Notice of Modification

Section 75W of the *Environmental Planning and Assessment Act 1979*

The development consent (DA 374-11-00) for the Sunrise Mine Project (formerly known as the Syerston Nickel Cobalt Project) granted by the then Minister for Urban Affairs and Planning on 23 May 2001.

Figure 1: Development Components

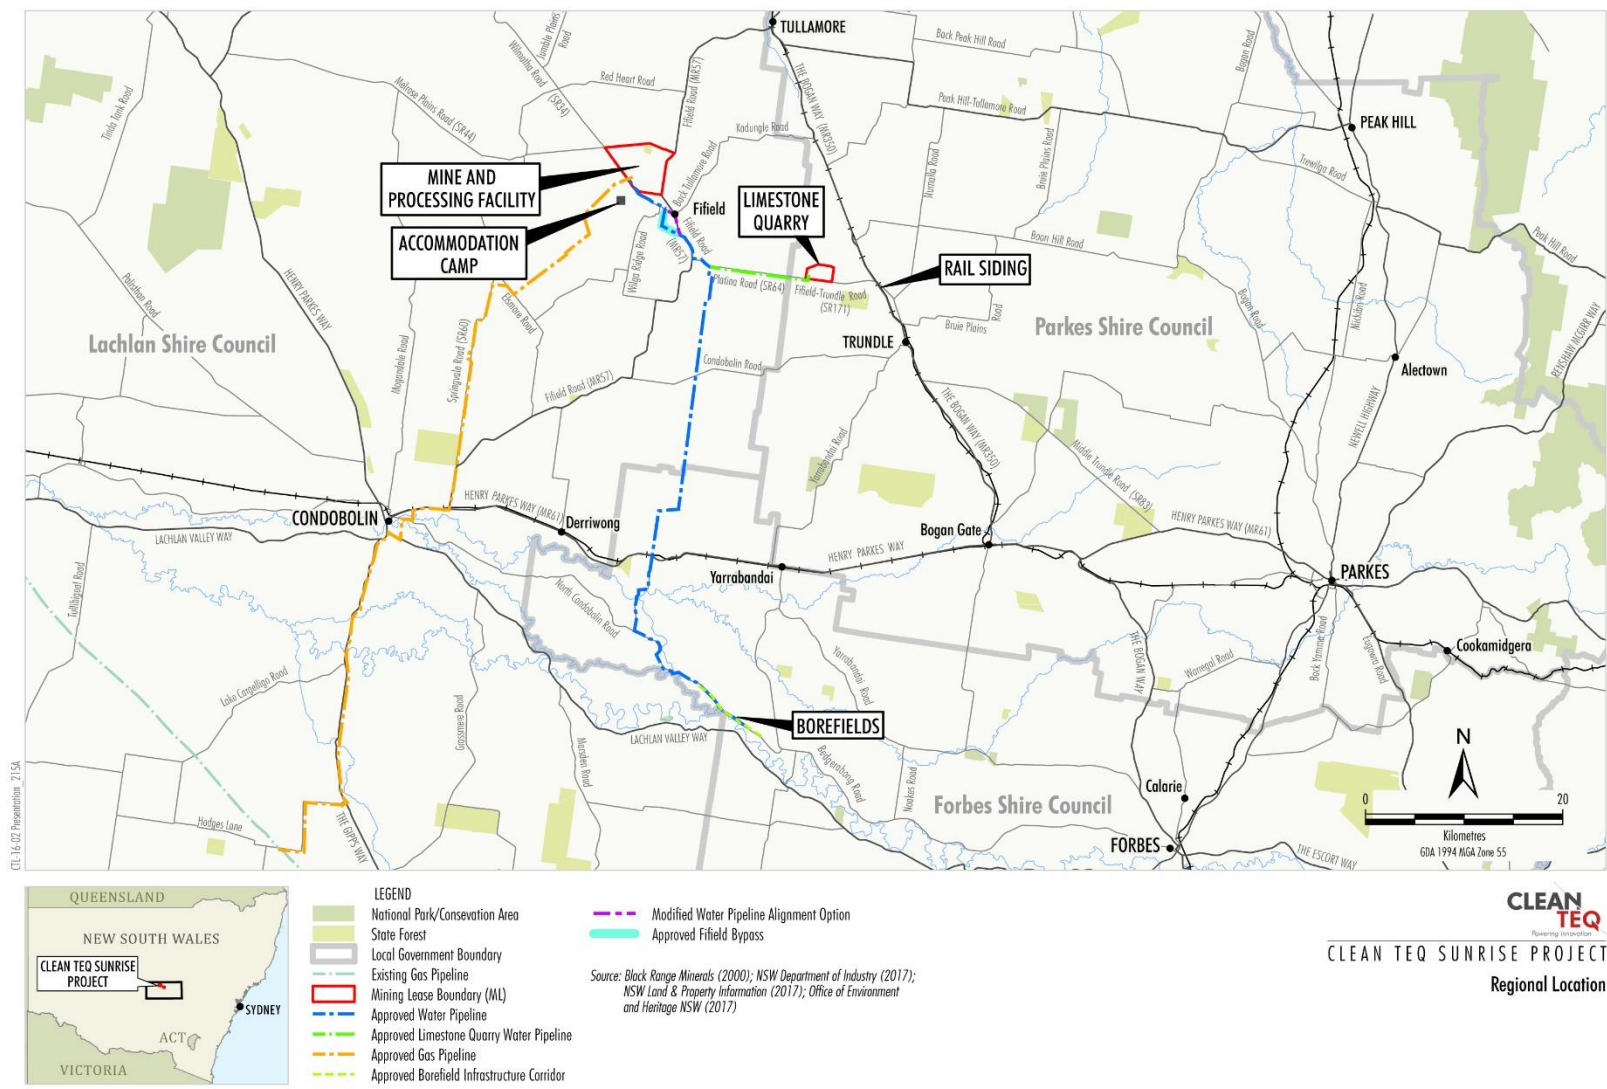
35. In Appendix 2, delete all figures and replace with:

Figure 2: Mine and Processing Facility – General Layout

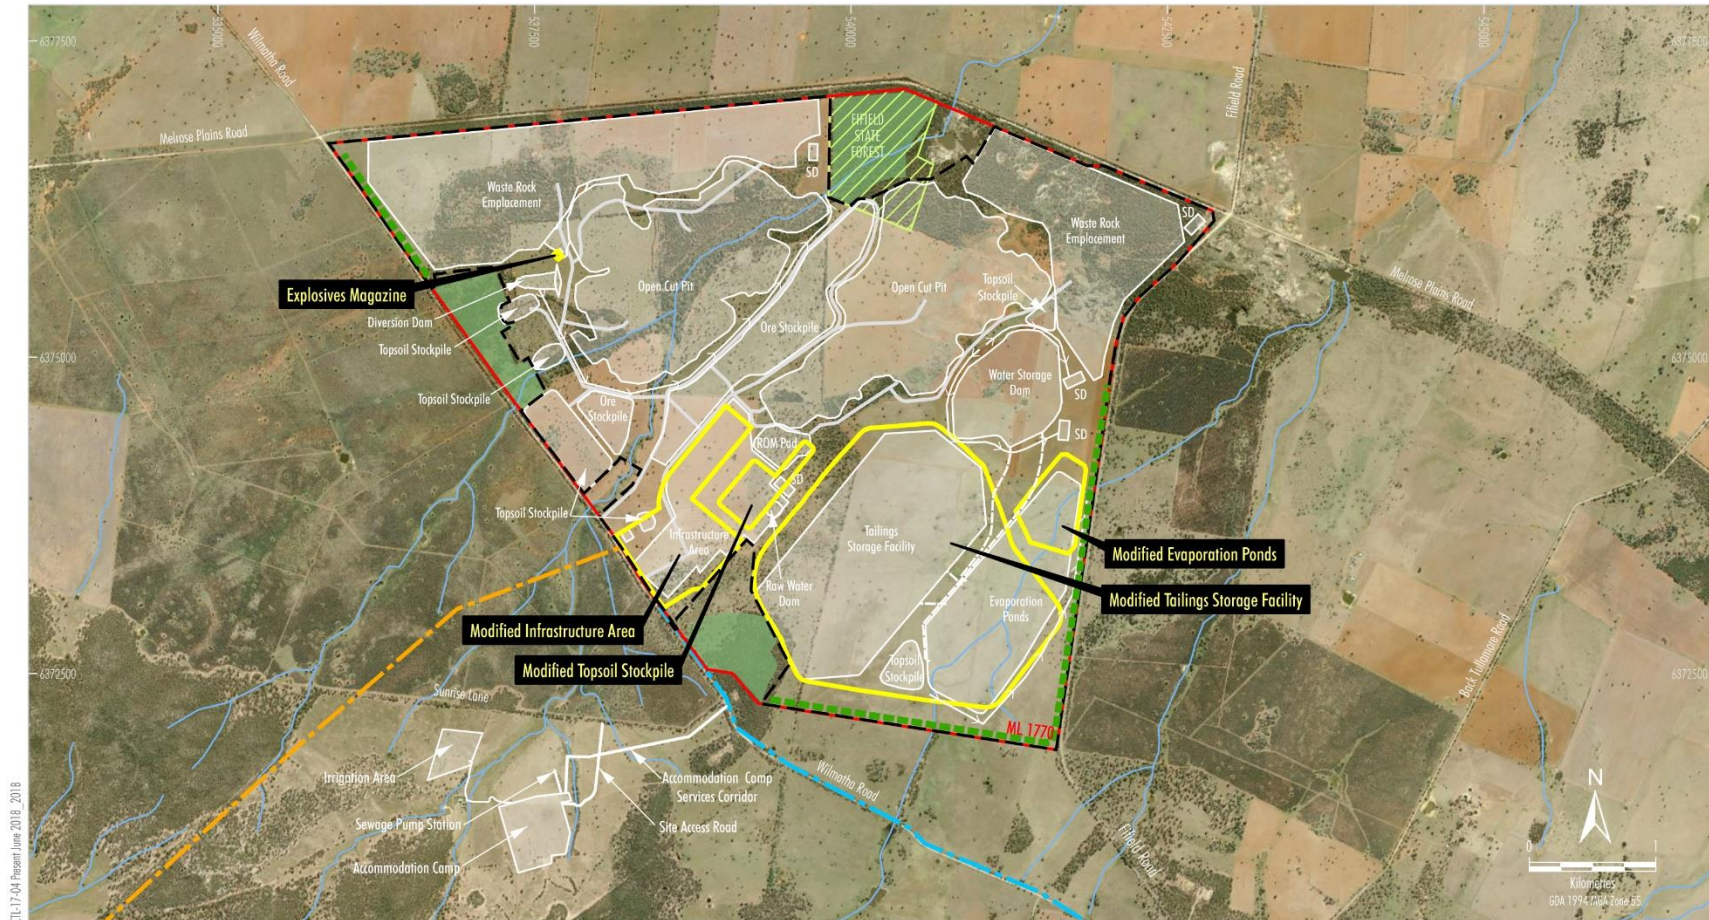
- ensure compliance with and enforcement of the protocol.
27. In Schedule 3, in Condition 48, after Condition 48(d) insert the following:
- (e) establish the vegetation screens (shown in Figure 2 in Appendix 2) within 3 years of the commencement of any development on the mine site (unless otherwise agreed by the Secretary), and maintain these screens throughout the life of the development;

Figure 8: Residences surrounding the mine

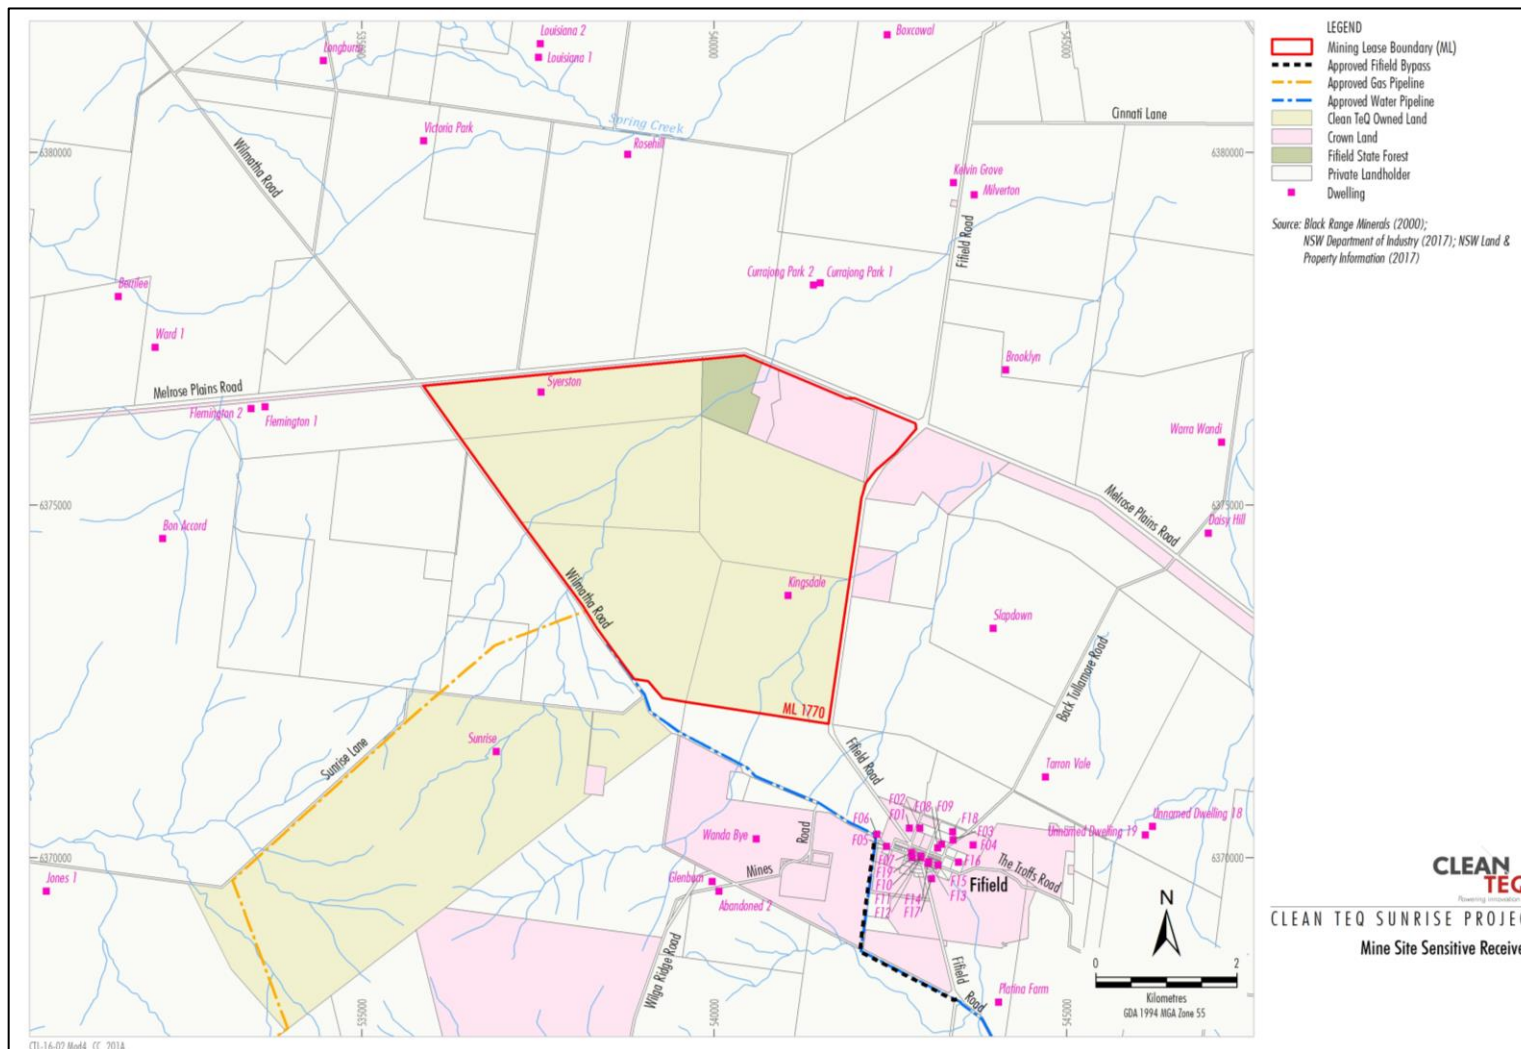
37. In Appendix 4, delete the figures and replace with:
